The Corporation of the
Town of Milton
Committee of Adjustment and Consent

Thursday, August 27, 2026, 6:00 p.m.
Council Chambers - In Person

Report To: Committee of Adjustment and Consent

Subject: 1461 Leger Way

Figure 1 - As-Built Parking Drawings
Figure 2 - Photographs of Overhead Pipe

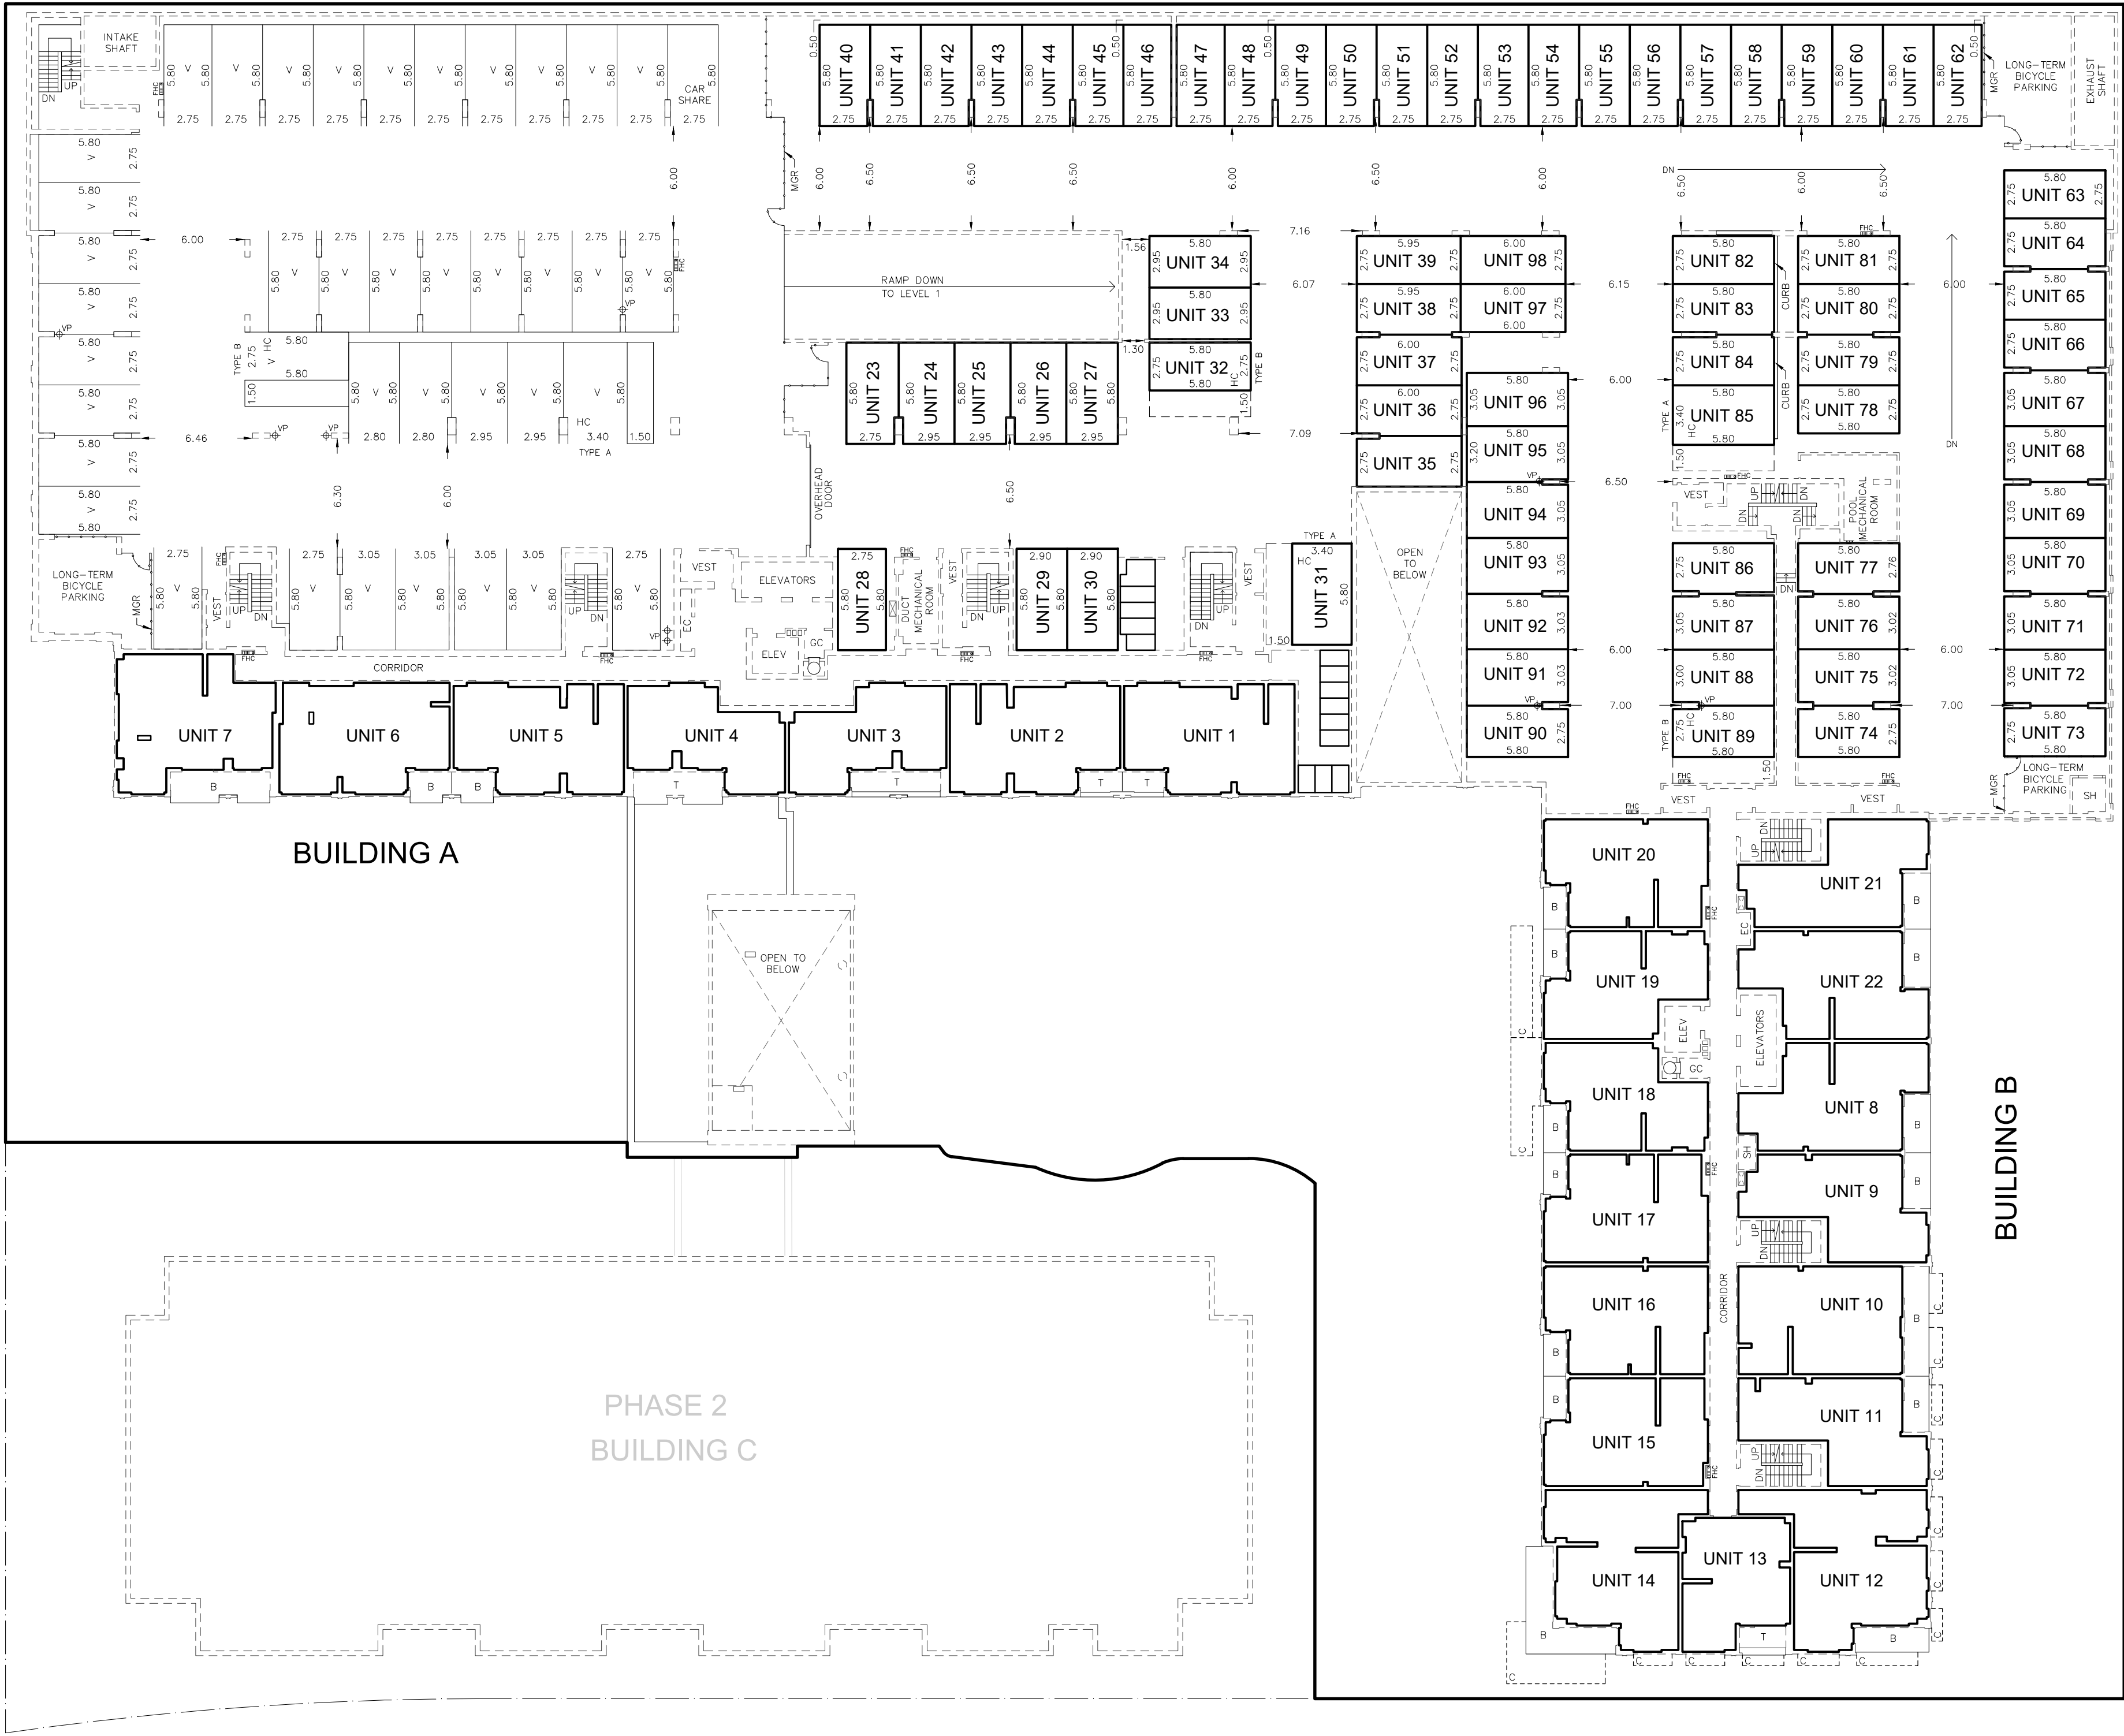
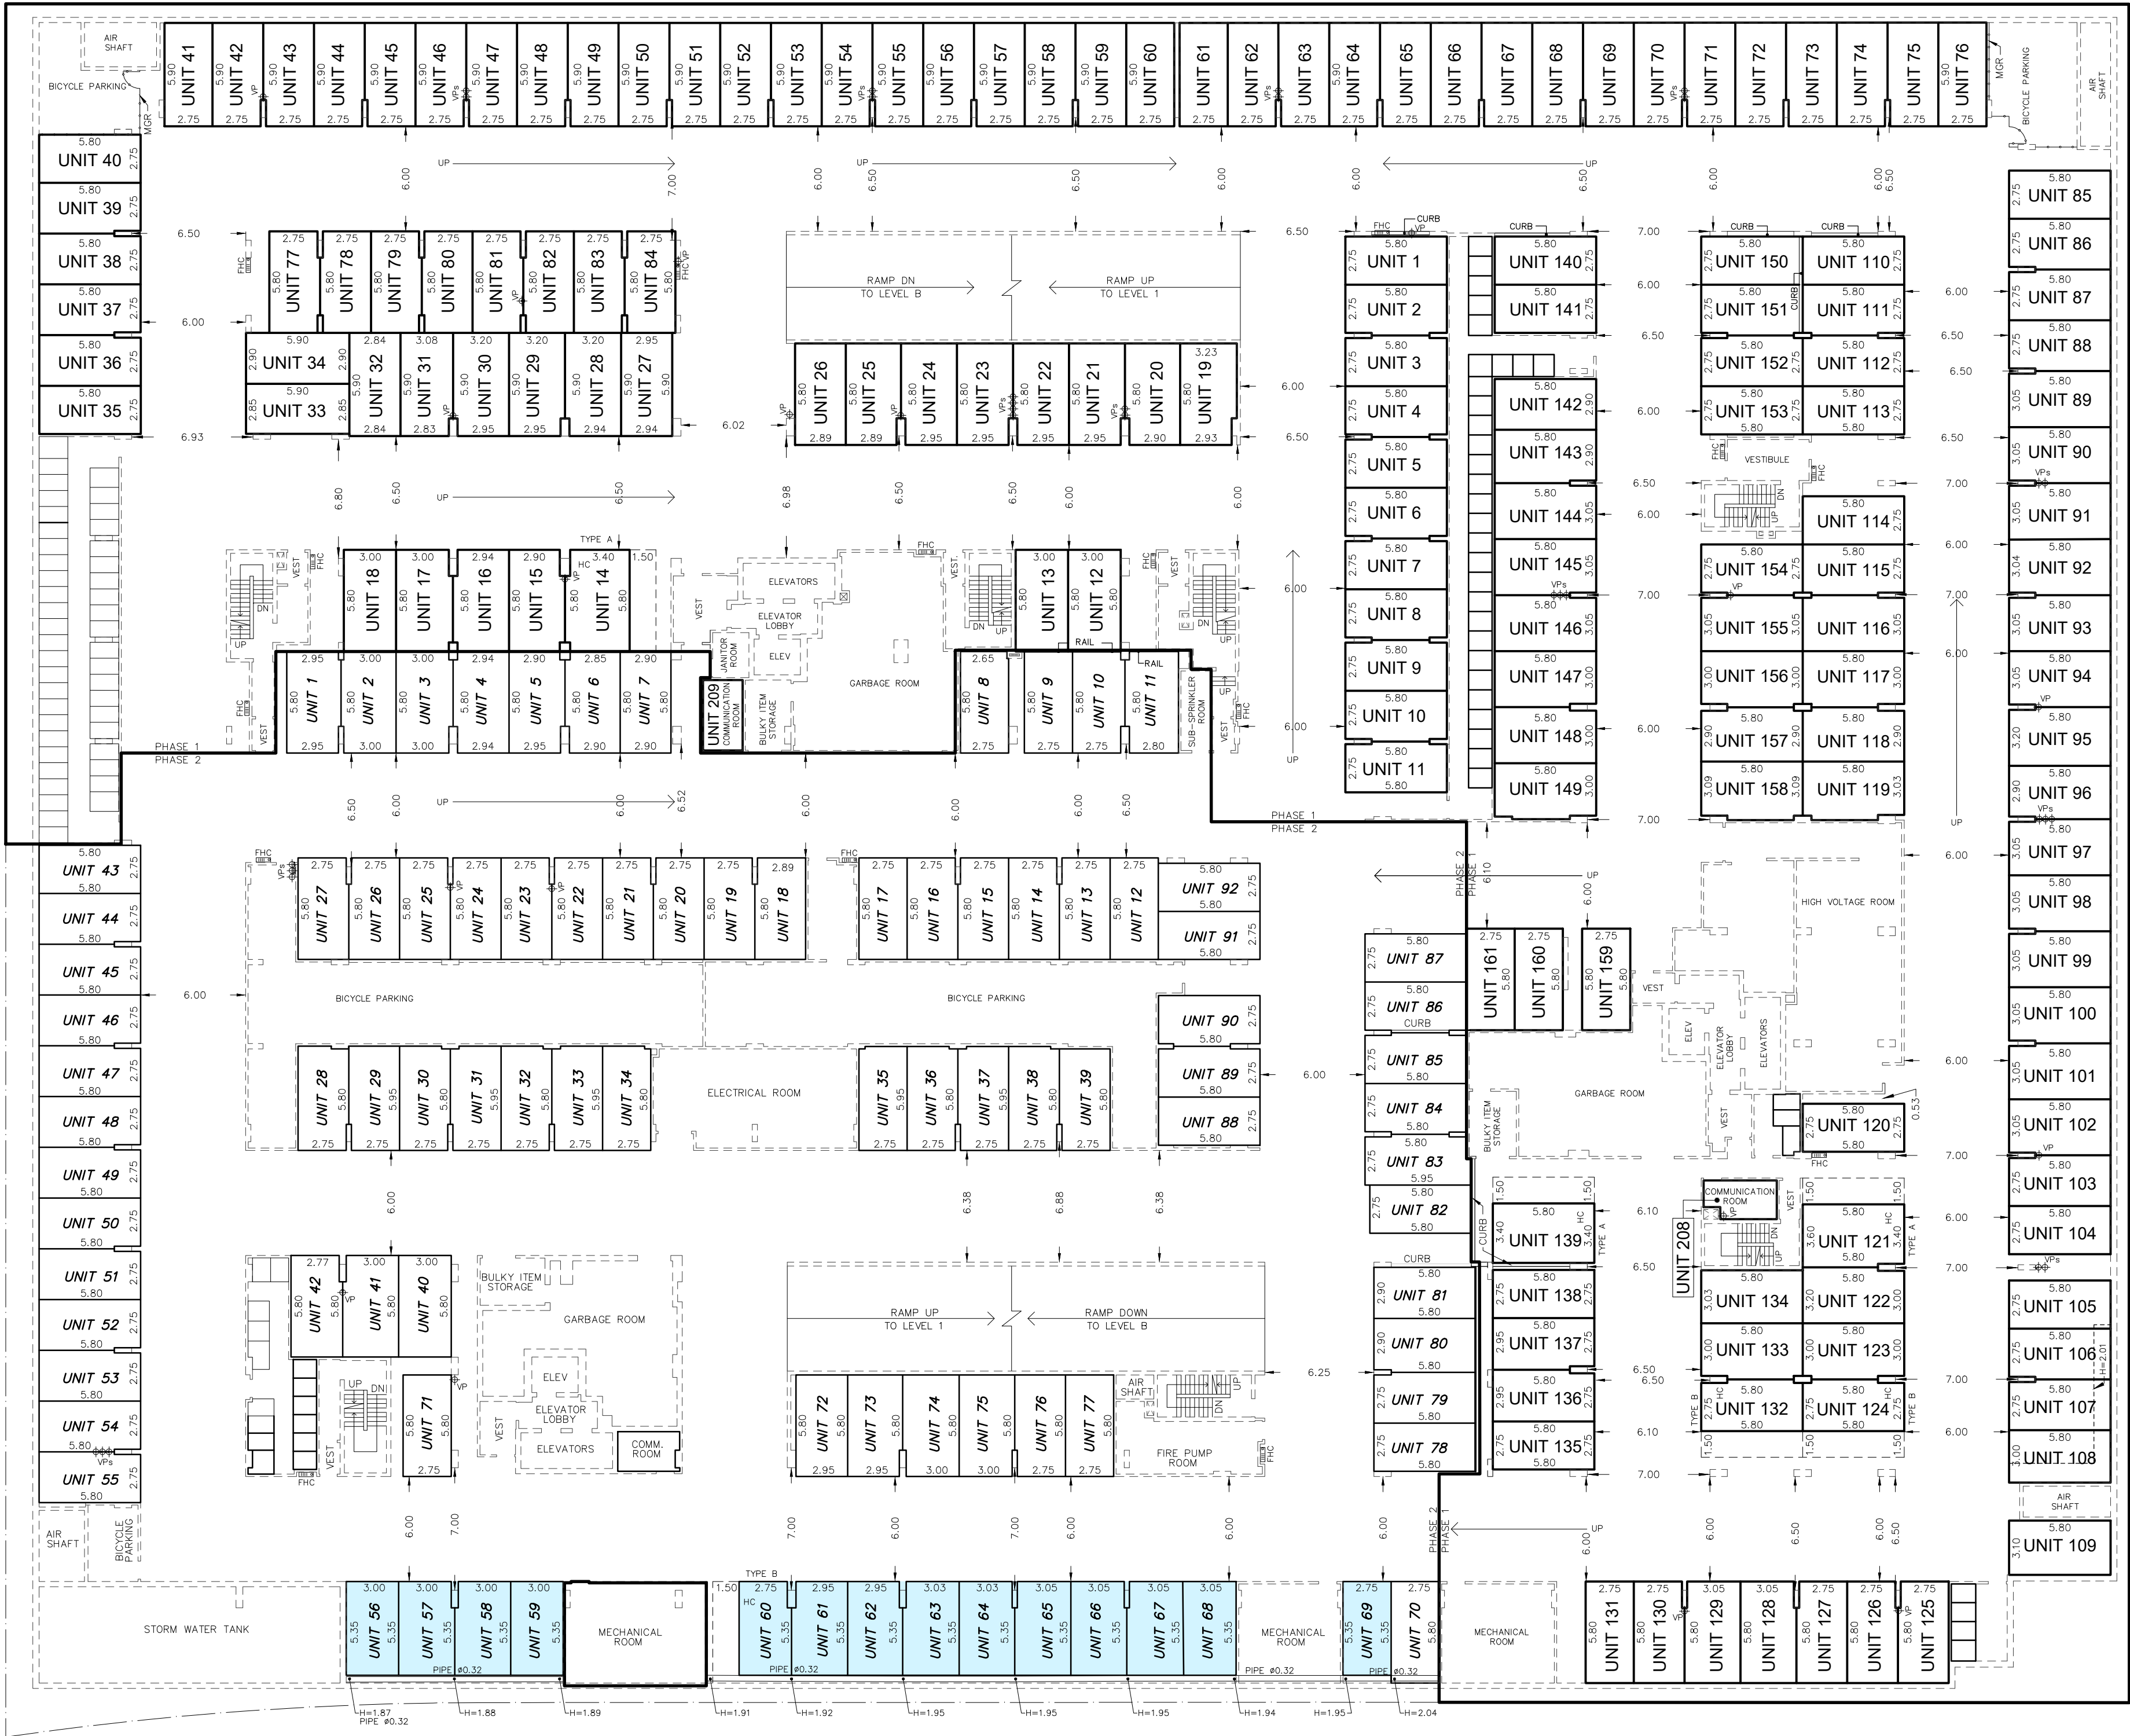
Variance One requests permission for two parking spaces to have a width of 2.7 metres, whereas a minimum width of 2.75 metres is required. The intent of this Zoning By-law provision is to ensure parking spaces are wide enough to permit safe and functional ingress and egress. Transportation staff have reviewed the as-built parking drawings and were satisfied that a width of 2.7 metres would have no impact on the usability or safety of either parking space. In light of this, and considering that the variance seeks a reduction of only 5 centimeters, Planning staff are satisfied that Variance One is minor and maintains the general intent of the Zoning By-law.

As with Variance One, the intent of this Zoning By-law provision is to ensure that parking spaces are long enough to accommodate a vehicle, and allow safe and functional ingress and egress. In this scenario, the requested variance is only required on a technicality, as a length of 5.8 metres is still provided. Transportation staff reviewed the as-built parking drawings and had no concerns with the proposed variance, noting that a vertical clearance of 1.87 to 1.95 metres should still provide sufficient clearance for the vast majority of passenger vehicles. As such, Variance Two is minor and maintains the general intent of the Zoning By-law.

1. THAT the minor variance shall apply in accordance with the as-built parking sketches prepared by KRCMAR and stamped and dated by Town Zoning on July 23, 2026.
2. THAT a redline revision to Site Plan file SP-33/19, reflecting the as-built parking space dimensions, shall be approved within two (2) years of the date of decision;
3. THAT the approval be subject to an expiry of two (2) years from the date of decision if the conditions are not met, if the proposed development does not proceed and/or a building permit is not secured.
